From: Franzone, Steve [<mailto:Steve.Franzone@fpl.com>]
Sent: Monday, September 17, 2012 8:46 PM
To: Comar, Manny
Cc: Maher, William; Burski, Raymond
Subject: DRAFT RAI Responses FPL Turkey Point 6 & 7 for eRAI 6006 Vibratory Ground Motion - Part 4 of 4

NRC RAI Letter No. PTN-RAI-LTR-040

SRP Section: 02.05.04 - Stability of Subsurface Materials and Foundations

NRC RAI Number: 02.05.04-3 (eRAI 6006)

Figure 1. Shear Wave Velocities (a) Average and Standard Deviation of the Measured V_s ; (b) Recommended Upper Boundary, Lower Boundary, and Average V_s

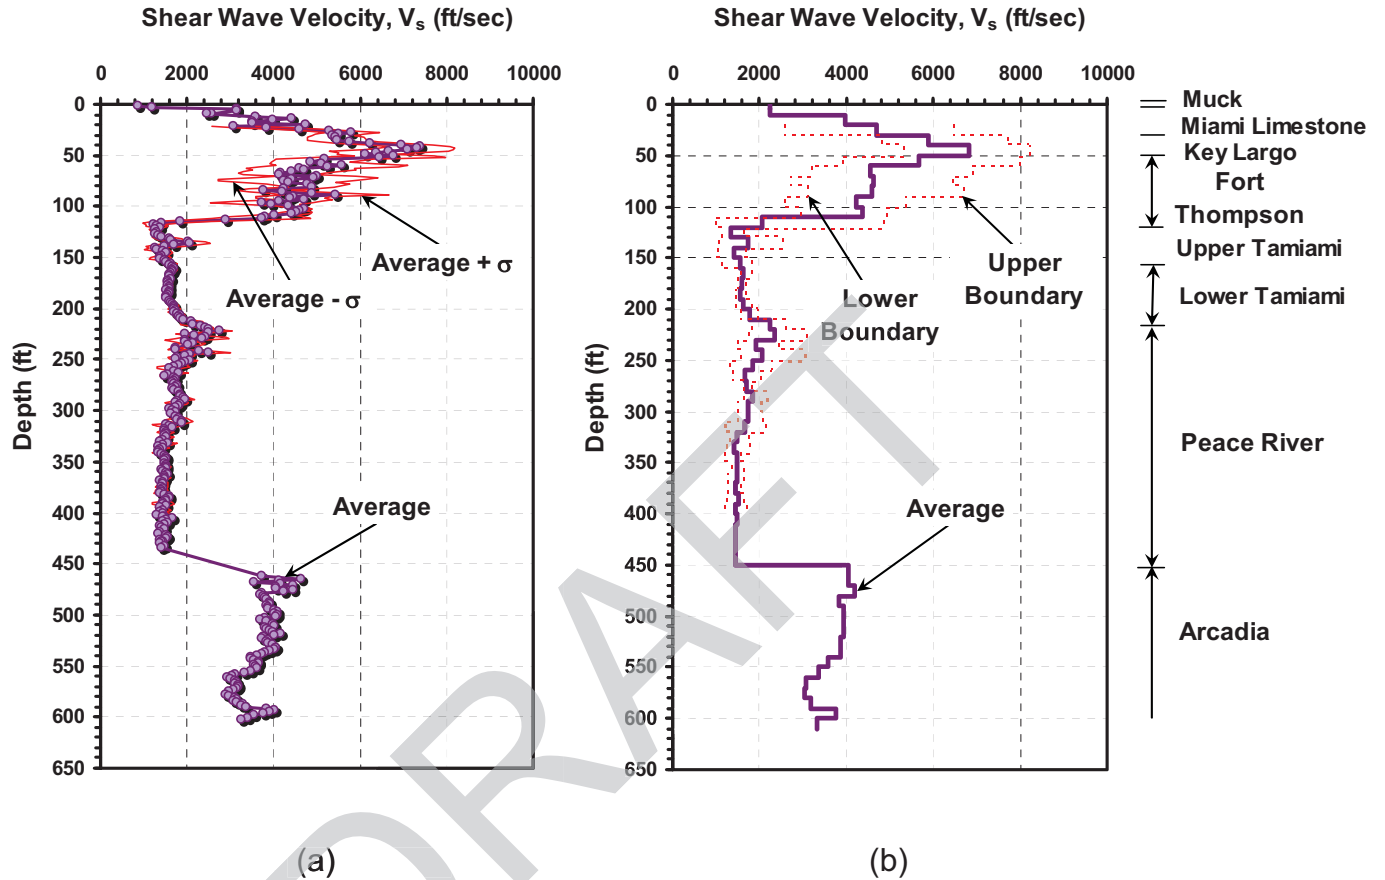
In accordance with NUREG-0800, Standard Review Plan, Chapter 2.5.4, "Stability of Subsurface Materials and Foundations," please describe how shear and compressive wave velocity values are selected for design in Table 2.5.4- 209. Provide correlations for shear and compressive wave velocity between Table 2.5.4-209 and Table 2.5.4-215 to indicate what percentile is used for recommended values. Given the large deviations, especially on Key Largo and Fort Thompson formations (see Figures 2.5.4-218 and 2.5.4-19 and Table 2.5.4- 215), explain how the selected single value for each stratum statistically reflects the entire layer.

The measured shear wave velocity (V_S) and compression wave velocity (V_P) values from each of 10 Suspension P-S velocity logging tests are plotted against depth in FSAR Figures 2.5.4-218 and 2.5.4-219, respectively. Figure 1(a) of this response provides a clearer picture of the variation of V_S within the Key Largo and Fort Thompson Formations. This figure shows the average and standard deviation of V_S in these formations at each measured depth interval in the 10 V_S borings. This figure is the basis for the V_S profile used for the site response analysis shown in Figure 1(b). Figure 1(b) is FSAR Figure 2.5.4-220. Figure 1(a) will be added to the FSAR. Figure 2 in this response is a typical plot of the measured values of V_S and V_P in one of the 10 borings. It shows the difference between the higher values in the Key Largo (25 to 50 feet depth) and the Fort Thompson (50 to 113 feet depth).

V_s readings were taken at 1.64-foot intervals in each boring, i.e., there were six readings per 10-foot depth. The depth interval between 30 and 40 feet in the above table is used to explain how the mean and standard deviations in the above table were derived. All 10 V_s borings covered this depth interval. Using the 10 V_s readings, a mean V_s value with plus/minus one standard deviation was computed and was assigned at each 1.64-foot interval. By averaging the six mean V_s values that fall in the 10-foot increment from 30 to 40 feet depth, the mean V_s of 5871 feet per second was obtained. The minimum of the six mean minus standard deviation V_s values was assigned as the low end V_s boundary (4785 feet per second), whereas the maximum of the six mean plus standard deviation V_s values is assigned as the high end V_s boundary (7675 feet per second). The mean V_s of 5799 feet per second for the Key Largo Limestone was computed by taking the average of these three mean V_s values, each corresponding to a 10-foot vertical depth interval. A best-estimate V_s of 5800 feet per second is recommended as shown in FSAR Table 2.5.4-209. Note that this value is close to the average value of V_s in the Key Largo Formation in Figure 1(b) in this response.

Figure 1(a) will be added to the FSAR as Figure 2.5.4-218 (b). Present Figure 2.5.4-218 will become Figure 2.5.4-218 (a).

Figure 2.5.4-218 (a) is a plot of all of the measured shear wave velocities to depths of 400 and 600 feet at Unit 6 and Unit 7, respectively. **Figure 2.5.4-218 (b) shows the average and standard deviation of all of the shear wave velocity measurements at each measurement depth.**

Figure 2.5.2-249 Median Profiles of Strain-Compatible Soil Damping
(Upper 800 feet) (Sheet 2 of 2)

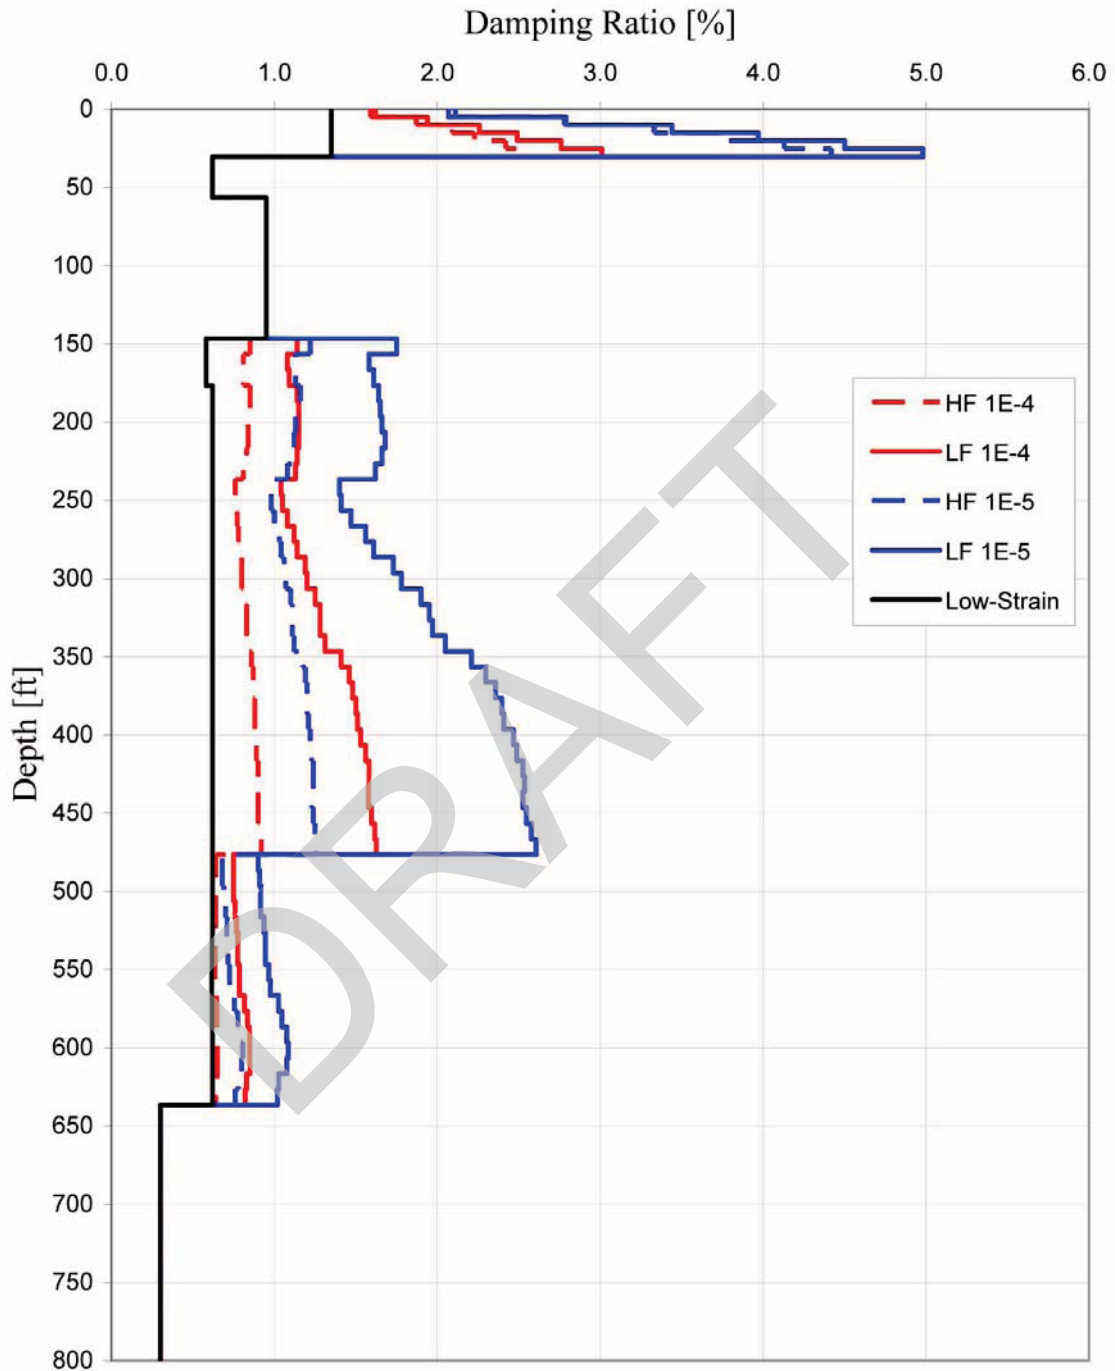
Section 2.5.4.7.3.3 "Shear modulus and Damping for Rock", indicates that the damping for rock is taken as 1%. The damping shown in Figure 2.5.2-249, which describes the soil properties used to develop the GMRS, indicates that a damping value of 0.5% was used in the analyses. In accordance with NUREG-0800, Standard Review Plan, Chapter 2.5.4, "Stability of Subsurface Materials and Foundations," please provide clarification as to the actual level of damping used in the analyses and provide a basis for its selection considering the large variability in RQD shown in Figure 2.5.4-215.

FSAR Figure 2.5.2-249 (Sheet 2 of 2) is reproduced in this response for illustrative purposes. This figure represents the full soil and rock column that includes approximately 30 feet of structural fill (with surface at El. +25.5 feet NAVD 88) above approximately 25 feet of Miami Limestone, overlying about 90 feet of rock consisting of the Key Largo and Fort Thompson Formations. The rock is underlain by soil of the Tamiami and Peace River Formations to about 475 feet depth. The Arcadia Formation, consisting of very weak rock mixed with some soil extends to about 640 feet depth, the limiting depth of the site subsurface investigation. The actual levels of damping used in the analyses are the values shown in FSAR Figure 2.5.2-249 (Sheet 2 of 2). The basis for selecting the value for each formation is described in the following paragraphs.

The constant damping ratio of the material below the Arcadia Formation, (i.e., below about 640 feet depth in FSAR Figure 2.5.2-249, Sheet 2 of 2), is 0.32 percent based on the median value of $kappa$ and associated uncertainty.

Figure 1. Shear Wave Velocities (a) Average and Standard Deviation of the Measured V_s ; (b) Recommended Upper Boundary, Lower Boundary, and Average V_s

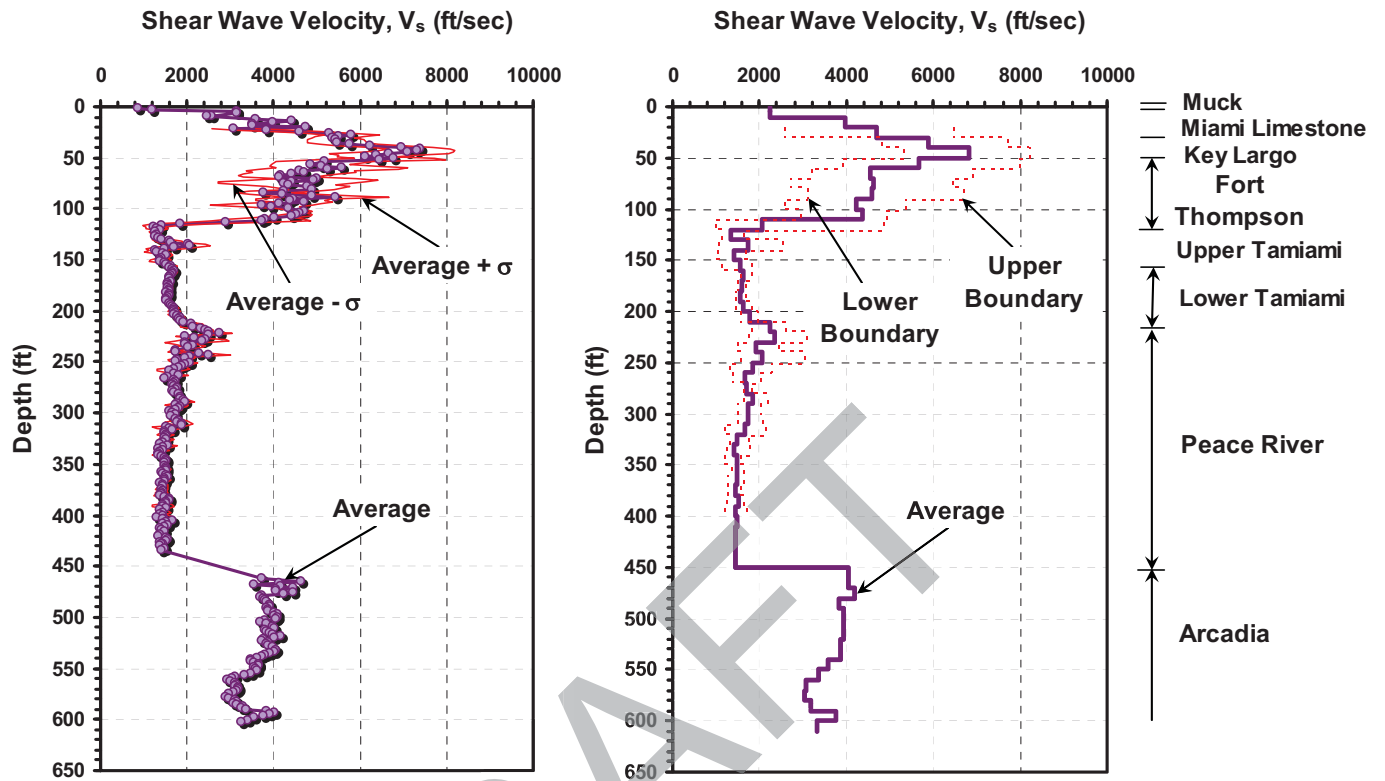
Figure 2.5.4-218 presents a plot of shear wave velocity measurements. Below the Fort Thompson formation, the soils are variously described as silty sands or silts and clays. However, the velocities do not show any change with depth. In accordance with NUREG-0800, Standard Review Plan, Chapter 2.5.4, "Stability of Subsurface Materials and Foundations," please indicate the data that was used to construct this figure and explain the uniformity in shear wave velocity below the Fort Thompson formation.

The shear wave velocity (V_s) profiles presented in FSAR Figure 2.5.4-218 are a compilation of the 10 suspension P-S velocity data sets, from B-601(DH), B-604(DH), B-608(DH), B-610(DH), B-620(DH) in Unit 6, and B-701(DH), B-704G(DH), B-708(DH), B-710G(DH), B-720G(DH) in Unit 7. As indicated in FSAR Subsection 2.5.4.4.2.1, these are the receiver to receiver V_s data that are given in FSAR Subsection 2.5.4, Reference 257. Figure 1(a) of this response provides a clearer picture of the variation of V_s within the Tamiami and Peace River Formations. This figure shows the average and standard deviation of V_s in these formations at each measured depth interval in the V_s borings. This figure is the basis for the V_s profile used for the site response analysis shown in Figure 1(b). Figure 1(b) is FSAR Figure 2.5.4-220. As described in the supplemental response to RAI 02.05.04-9, Figure 1(a) will be added to the FSAR.

In summary, the V_s data in FSAR Figure 2.5.4-218 are compiled from the receiver to receiver data from the 10 suspension P-S velocity data sets. There is some variation of V_s with depth, but this appears to be more related to fines content than overburden pressure.
